PANEL ASSESSMENT BRIEFING REPORT
HUNTER AND CENTRAL COAST REGIONAL PLANNING PANEL

PANEL REFERENCE & DA NUMBER	PPSHCC-115 – DA2021/01754
PROPOSAL	<p><i>Health Services Facility</i> – Involves 5 levels with:</p> <ul style="list-style-type: none"> • 1st and 2nd level including car parking, • 3rd & 4th levels includes health consulting rooms & administration • 5th level Operating Theatre (Out patients only – day treatments)
ADDRESS	Lot 11 DP 1221375 43 Date Street Adamstown
APPLICANT	Andrew Brook
OWNER	GPV Adamstown Pty Ltd atf GPV Adamstown Trust
DA LODGEMENT DATE	10 January 2022
APPLICATION TYPE	Development Application
REGIONALLY SIGNIFICANT CRITERIA	Clause 5, Schedule 6 of the State Environmental Planning Policy (Planning Systems) 2021: <i>Private infrastructure and community facilities over \$5 million (health service facilities)</i>
CIV	\$12,564,003.00 (excluding GST)
CLAUSE 4.6 REQUESTS	No clause 4.6 variations proposed
LIST OF ALL RELEVANT PLANNING CONTROLS (S4.15(1)(A) OF EP&A ACT)	<p>Environmental planning instruments: s4.15(1)(a)(i)</p> <ul style="list-style-type: none"> • State Environmental Planning Policy (Resilience and Hazards) 2021 – Chapter 4 Remediation of Land (prev

Figure 14 – Victoria St & Southern Upper Setback Envelopes (exceedances hatched yellow)

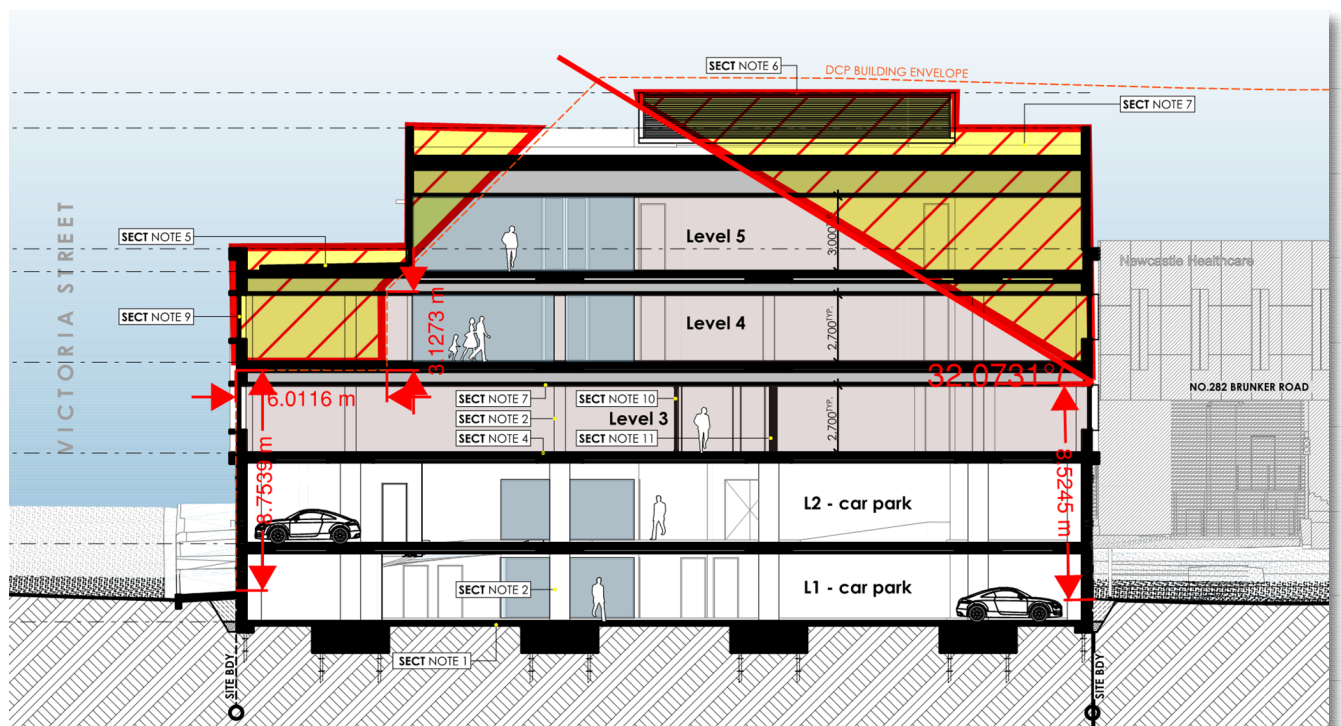
Figure 14 below shows the annotated upper setback envelopes for Victoria Street and southern boundary from Section 6.08 on the proposed elevations with the variations highlight in yellow and hatched. The adopted southern boundary upper setback envelope under the DCP intentionally has a lesser 32 degree angle to minimise overshadowing impacts on neighbouring properties.

Figure 15 – Date St Upper Setback Envelope & Street setback (exceedances noted & Date St setback hatched in orange)

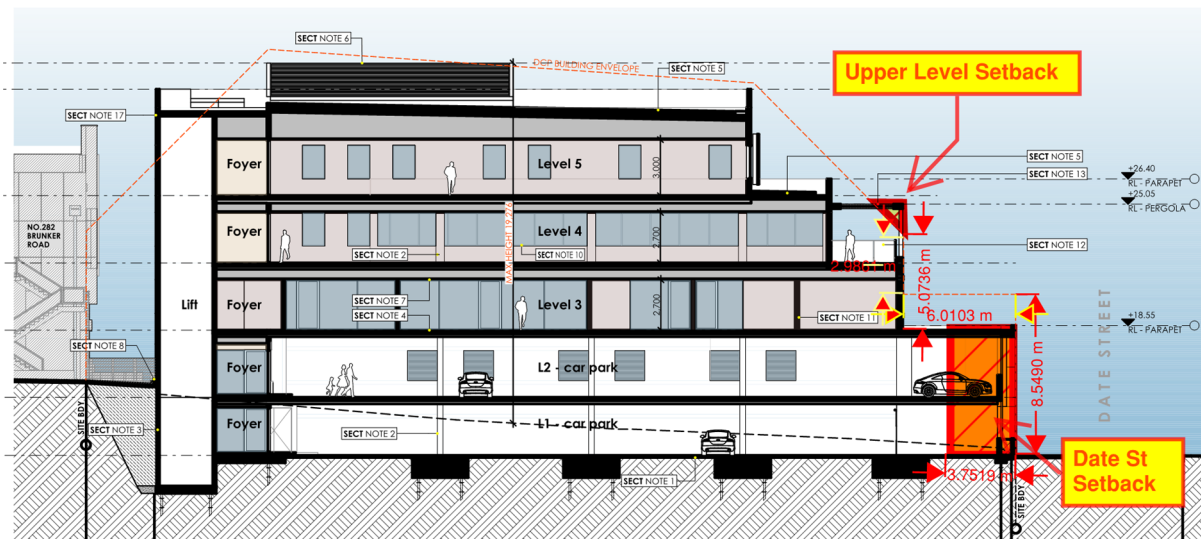
Figure 15 further below shows the Date Street upper setback envelope exceedance which may small be contributes to the overall impacts. Additionally it shows the exceedance of the street front setback to Date Street discussed further below. These variations are highlighted in yellow and orange (southern in yellow and Date Street in orange).

The proposal does not meet control 14 in terms of 4.5 metre setback. In an assessment of the current application it has been recommended to provide at least 3.75 metre landscaped setback to Date Street to assist the streetscape and visual appearance interface of the development in context of the surrounding development, especially the western side of Date Street. It is advised that the 3.75 metre was required as a minimum as the site had previously dedicated land as road widening (0.75 metres) along the Date Street frontage (DP1221375 – 11/8/2016) when the neighbouring site to the south was developed (i.e. Stage 1 medical centre). The variation to this setback control (i.e. 3.75 metre) is shown in **Figure 15** above.
